## **URGENT MODIFICATION CONSULTATION DOCUMENT 2**

**MODIFICATION PROPOSAL P18**

**Removing/Mitigating the Effect of System  
Balancing Actions in the Imbalance Price  
Calculations**

**Prepared by ELEXON on behalf of the Pricing  
Issues Modification Group**

Graph 1 May 2001 based on Existing Price Calculation

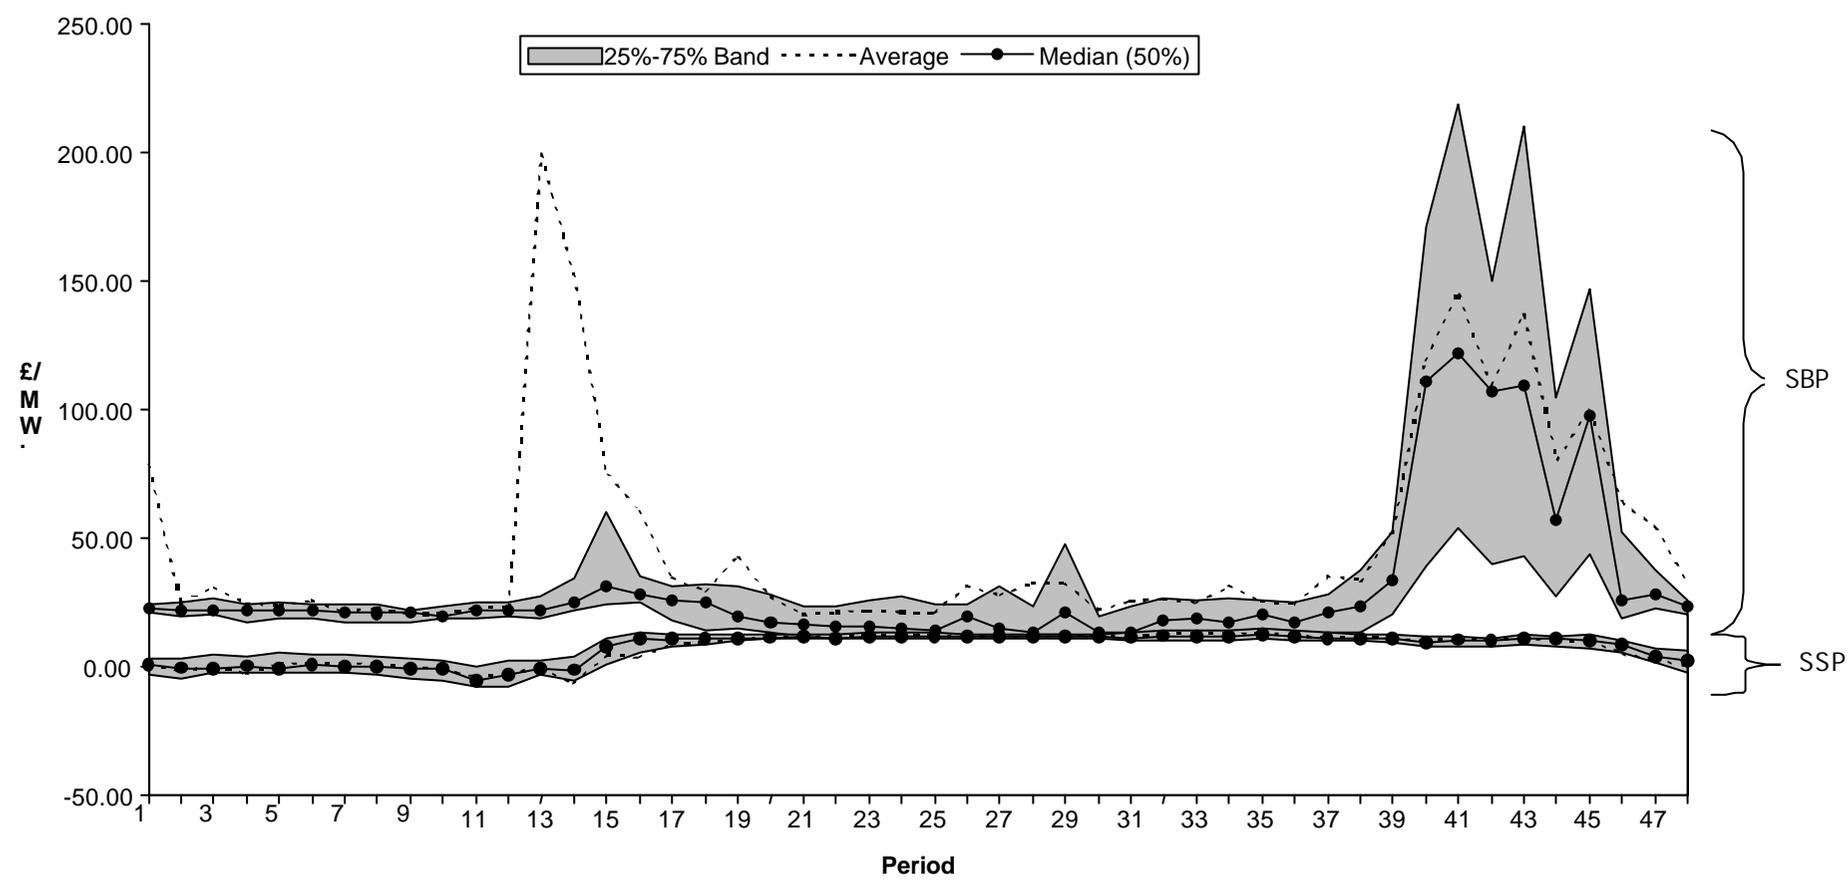
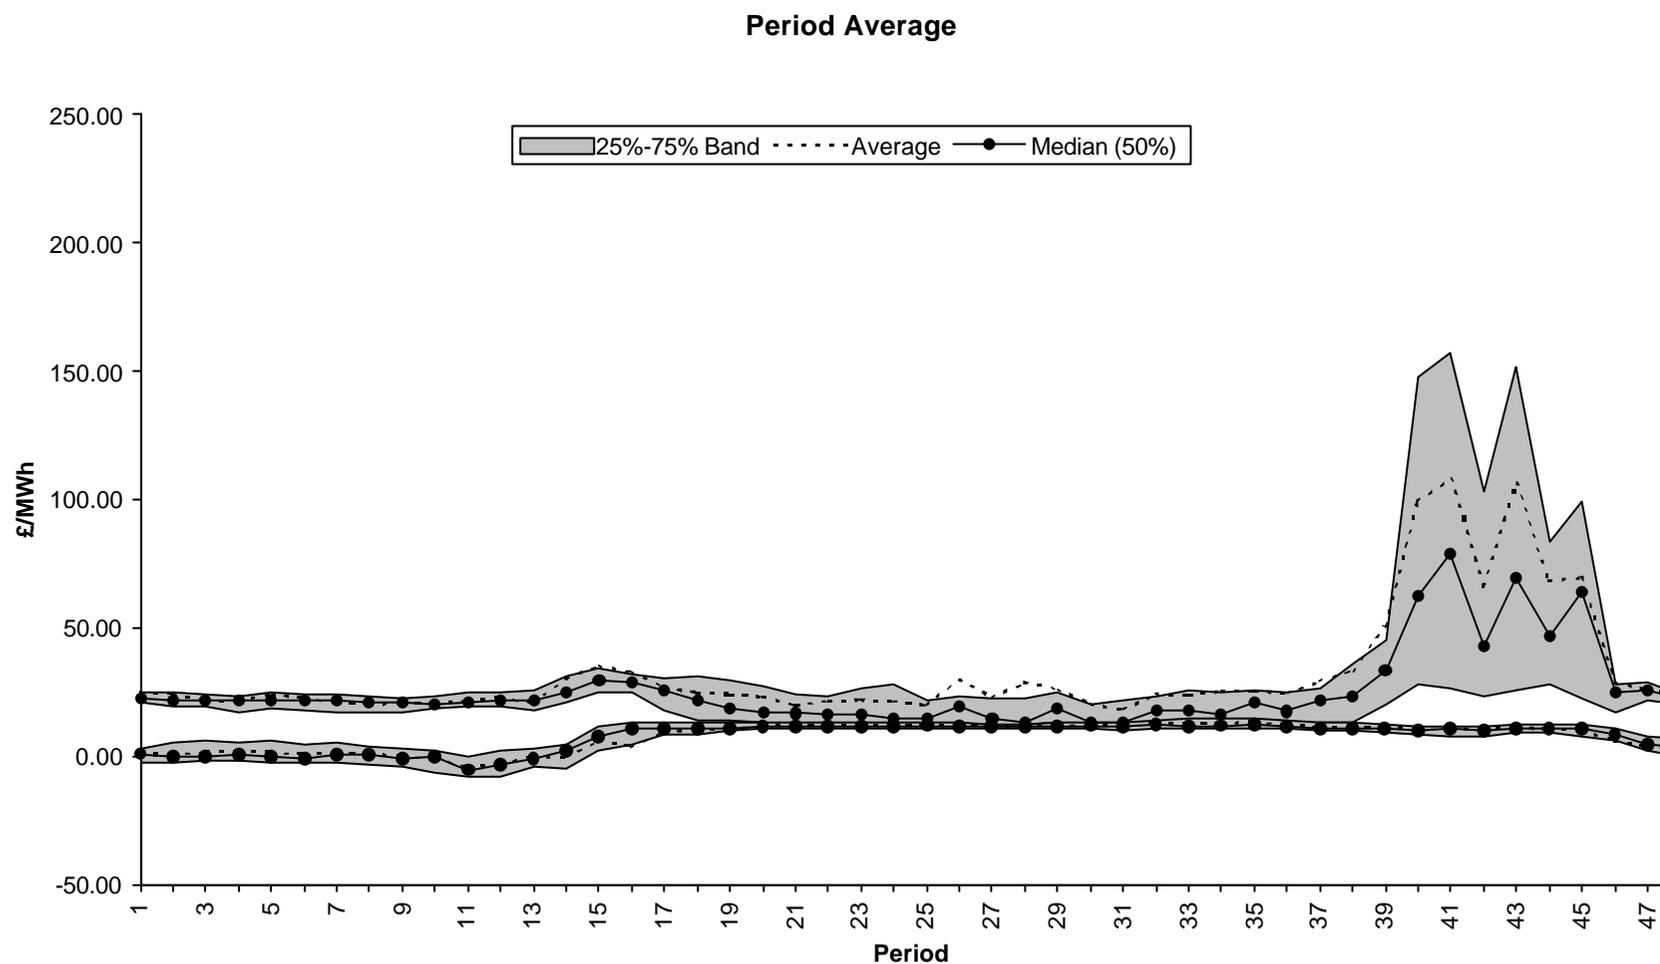
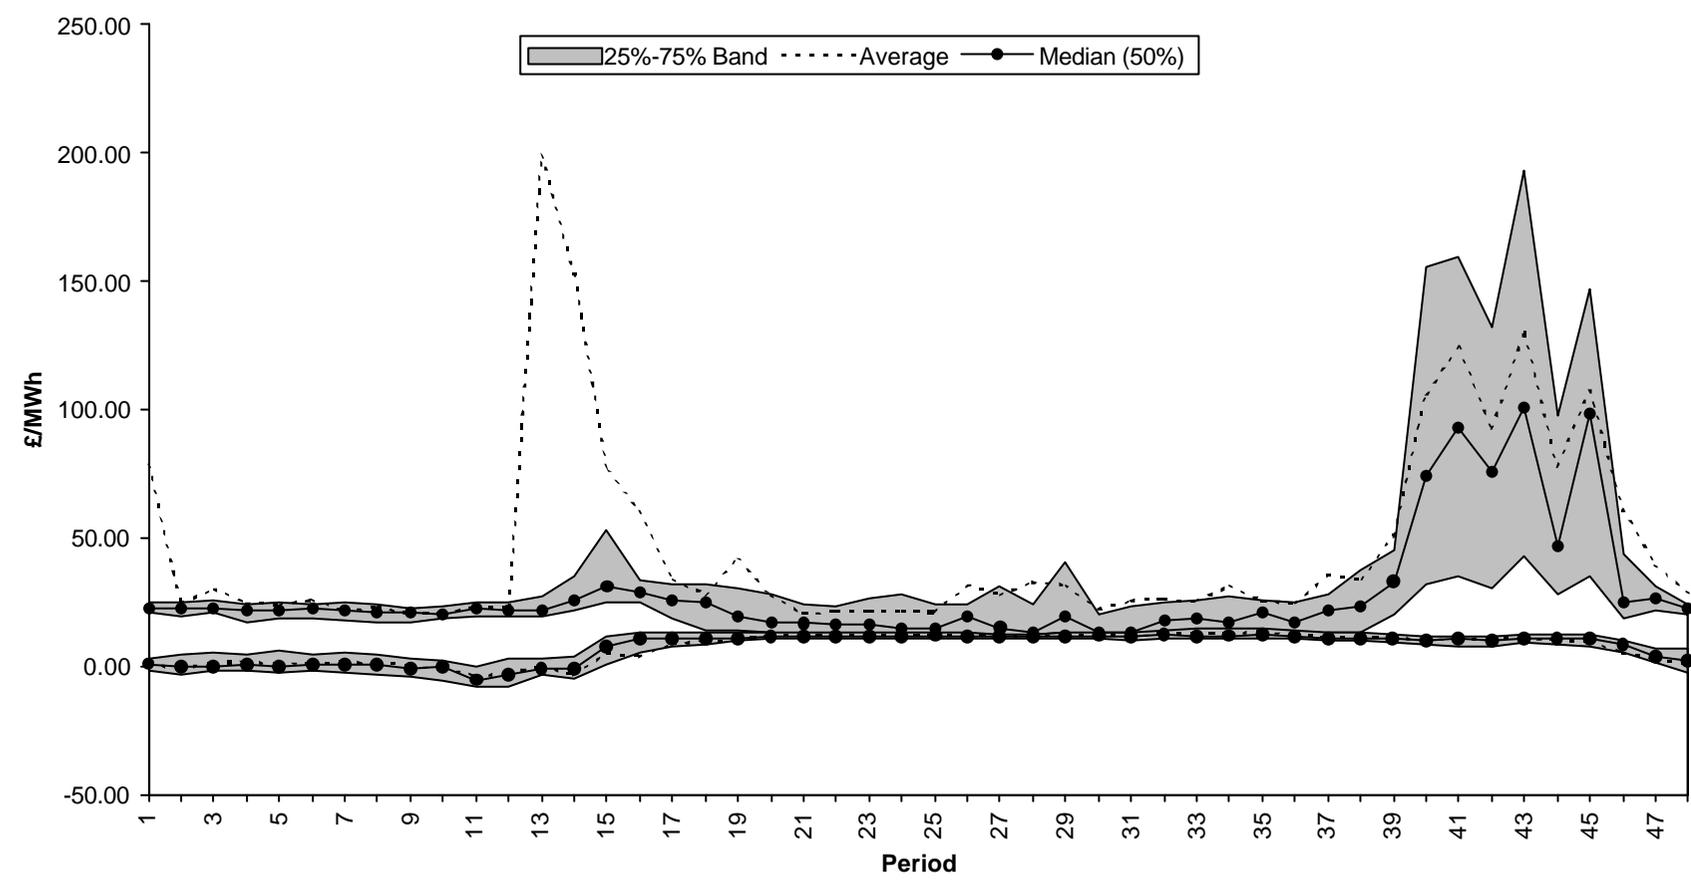
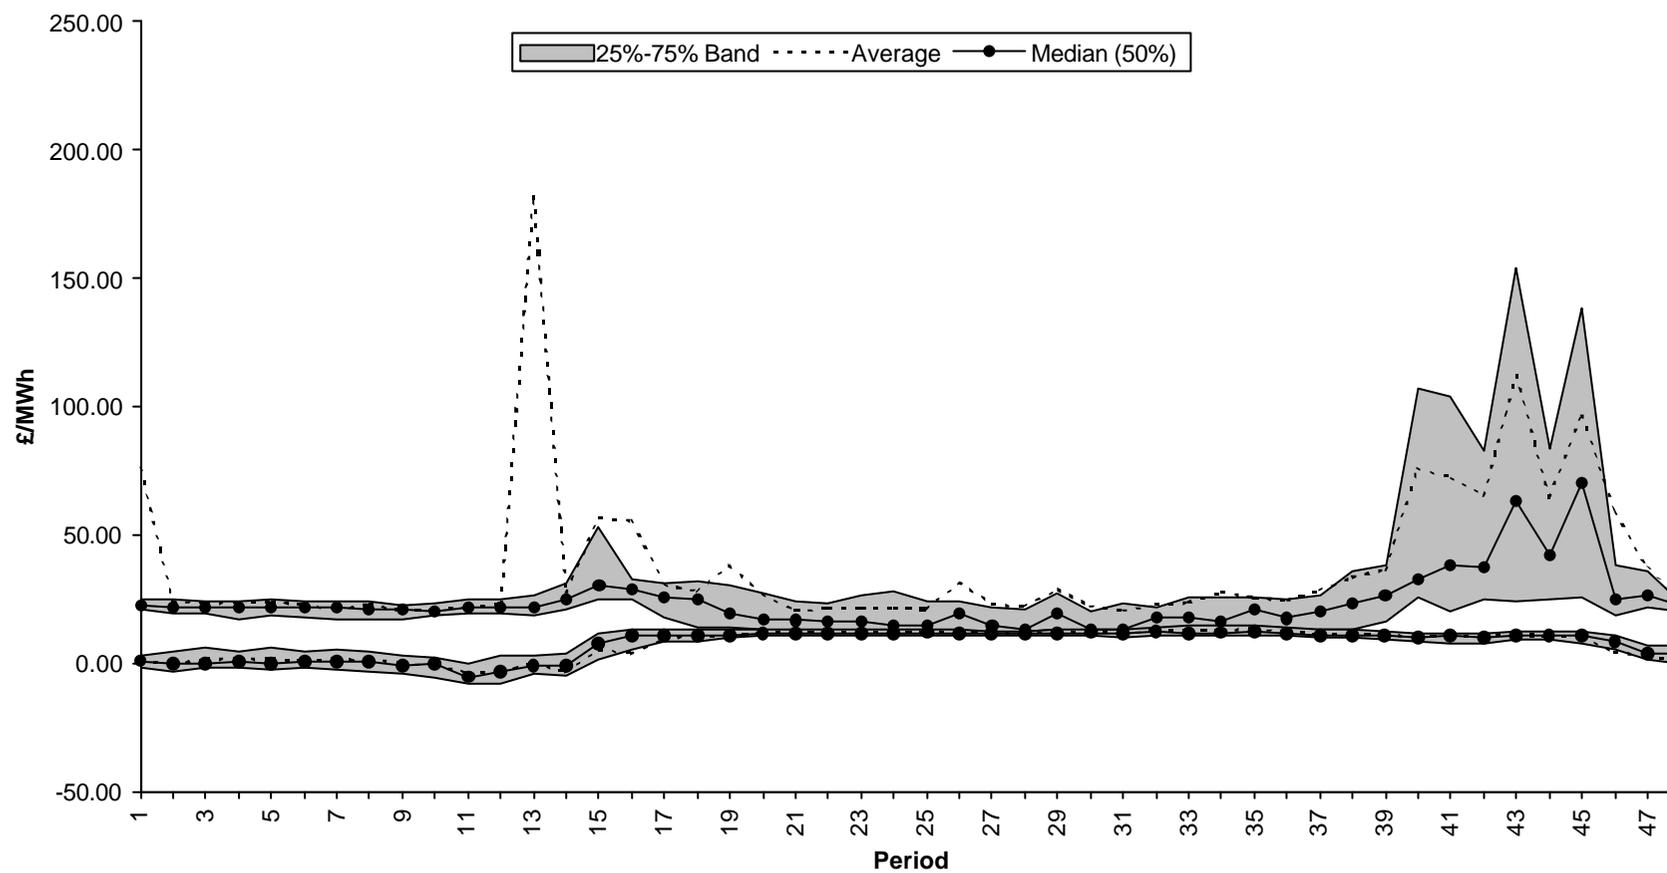
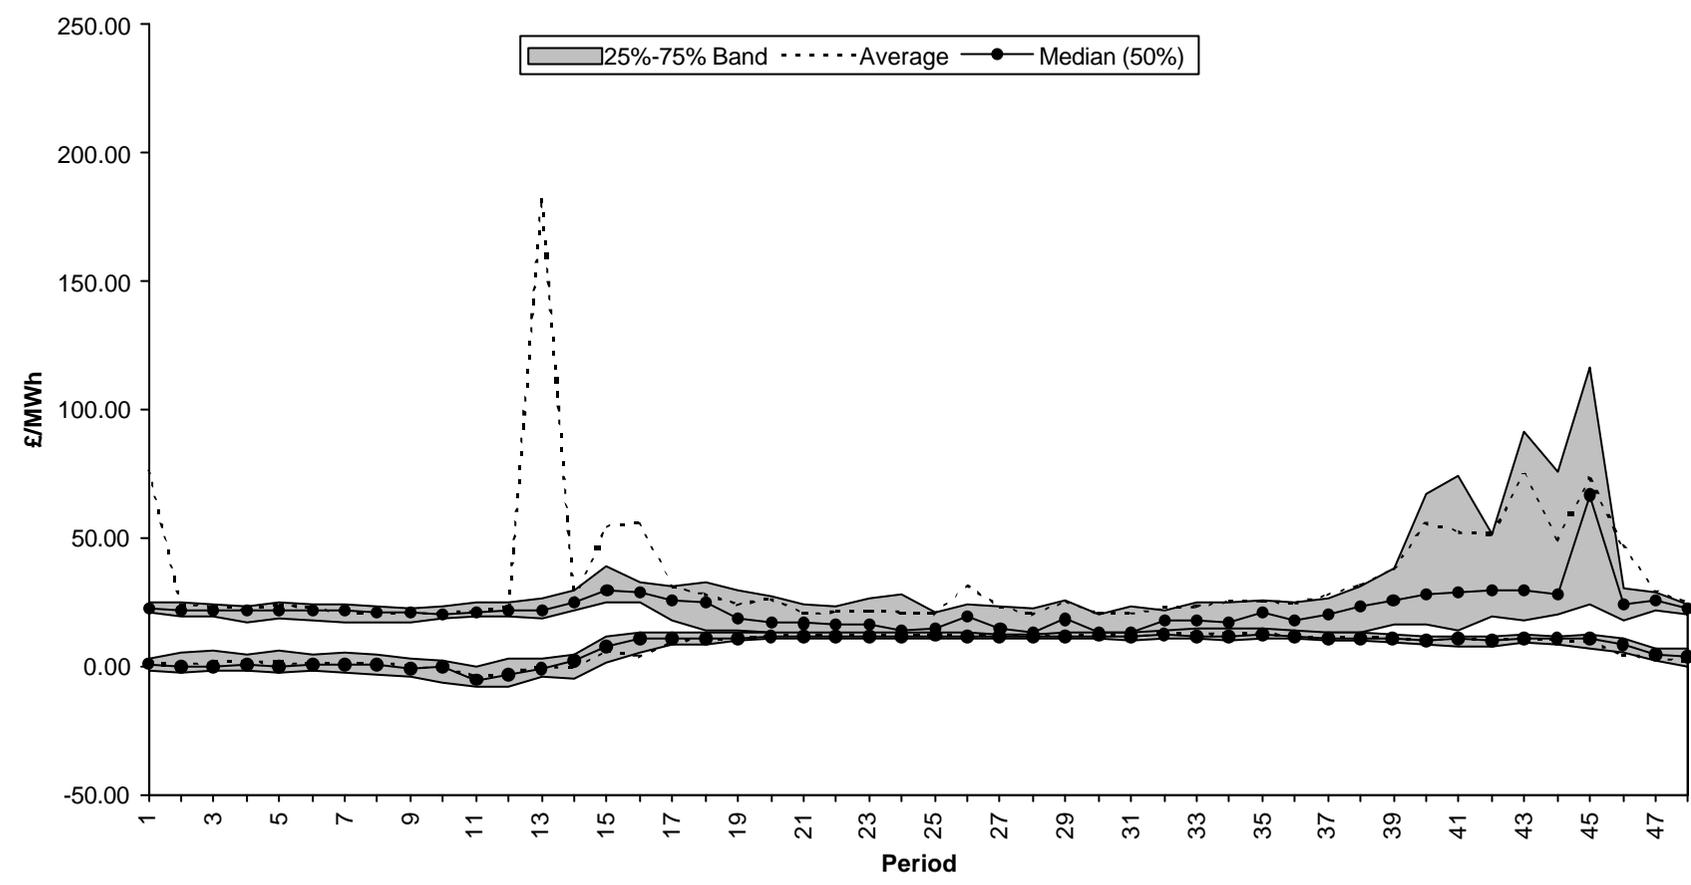
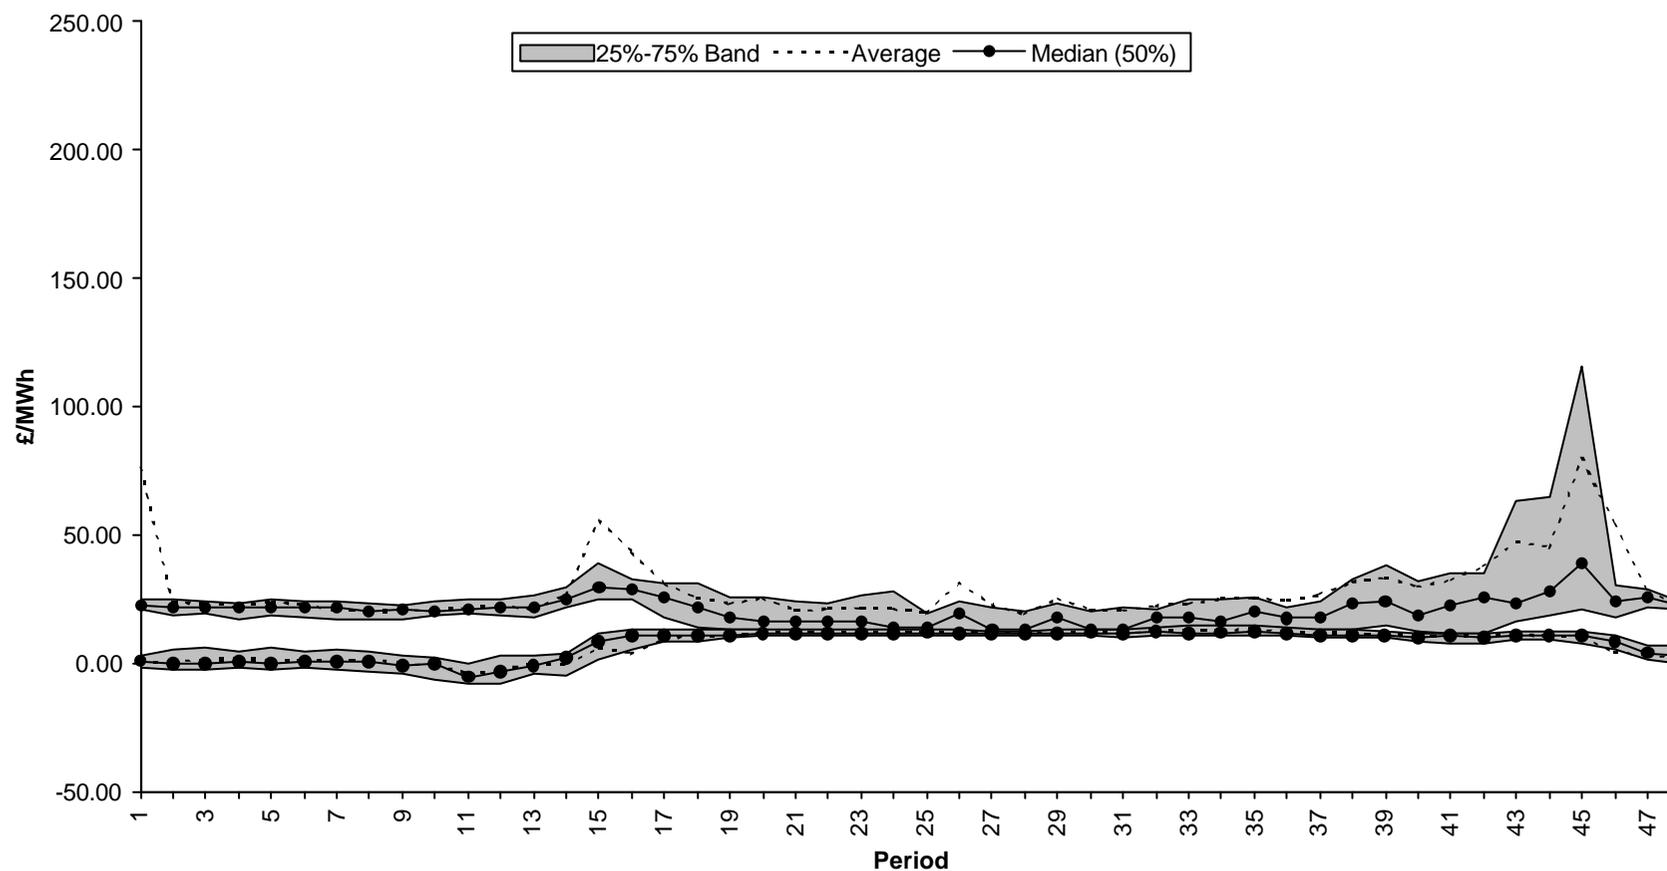
**Discussions in the Modification Group noted that as CID was increased, the "spikiness" of the data, particularly around period 14 reduced, clearly indicating the extreme values of System Buy Prices and System Sell Prices were being removed.**

**However, with larger values of CID the range of prices in periods 39-45 were also significantly dampened.**

- **A CID of 15 minutes would not remove all spikes;**
- **A CID of 30 minutes will flatten the evening peak;**
- **CID should not, in any event, be set to be greater than 30 minutes (i.e.  $CID_{max} = 30$  minutes)**
- **Some prices can increase (although this is unusual, and occurs because relatively cheap offers or bids are removed);**
- **50% of periods during the day already have a price determined on a default basis;**
- **CID can increase the incidence of defaulting prices to 50% during the evening as well.**

- **Modification P18A was effective at removing short duration acceptances from the price calculations;**
- **The value of CID could be selected so as to strike a balance between removing sufficient of those acceptances deemed to “system balancing” actions, but not tagging too many acceptances deemed to be “energy balancing actions”.**
- **The view of the members of the Modification Group present on 28<sup>th</sup> June 2001 was that based on the data analysis presented, CID should be set somewhere in the range between 10 and 20 minutes.**
